Access Compliance Report

Public Rights-of-Way

(Curb Ramps)

Intersection ID: 15160	Main Street: GRIFFITH_ST	Cross Street: S_TRYON_ST	Location: NE
ADA ID: 18C4D5B438AF	Ramp Type: Perp	Initial Pass/Fail: Fail	Overall Compliance: No
Severity Score: 22.5			
Codes/Mitigation Info/Possible Solution		Field Measurements/Component Compliance

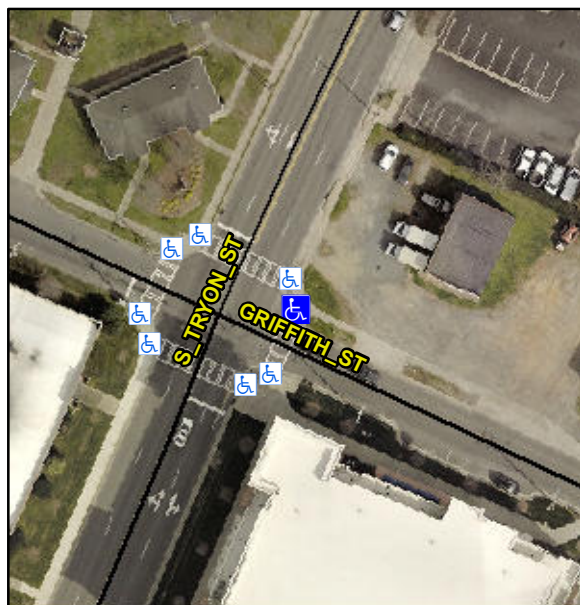
Not Found, R304.5.1, R304.2.2, R304.5.3

Compliance	Description	Data	Compliance	Description	Data
N/A	Ramp Length (in)	67.0	No	Ramp Slope (%)	9.5
No	Ramp Width (in)	47.5	No	Ramp XSlope (%)	2.1
N/A	Flare Type LT	N/A	N/A	Flare Type RT	N/A
N/A	Flare Slope LT (%)	N/A	N/A	Flare Slope RT (%)	N/A
N/A	Flare Traversable LT?	N/A	N/A	Flare Traversable RT?	N/A
N/A	Landing Length (in)	N/A	N/A	DWS Provided?	N/A
N/A	Landing Width (in)	N/A	N/A	DWS Contrast?	N/A
N/A	Landing Slope (%)	N/A	N/A	DWS Length (in)	N/A
N/A	Landing X Slope (%)	N/A	N/A	DWS Full Width?	N/A
N/A	Landing Curb? (Y/N)	N/A	N/A	DWS Offset (in)	N/A
N/A	Shared Landing?	N/A			
N/A	Gutter Ponding?	N/A	N/A	Gutter Slope (%)	N/A
N/A	Gutter Lip Ht (in)	N/A	N/A	Gutter X Slope (%)	N/A
N/A	Painted X Walk1?	Yes	N/A	Painted X Walk2?	N/A
	X Walk 1 Direction	To SW		X Walk 2 Direction	N/A
N/A	X Walk 1 Width (in)	105.0	N/A	X Walk 2 Width (in)	N/A
	X Walk 1 Slope (%)	1.0		X Walk 2 Slope (%)	N/A
	X Walk 1 X Slope (%)	0.8		X Walk 2 X Slope (%)	N/A

Remove & Replace Entire Ramp.
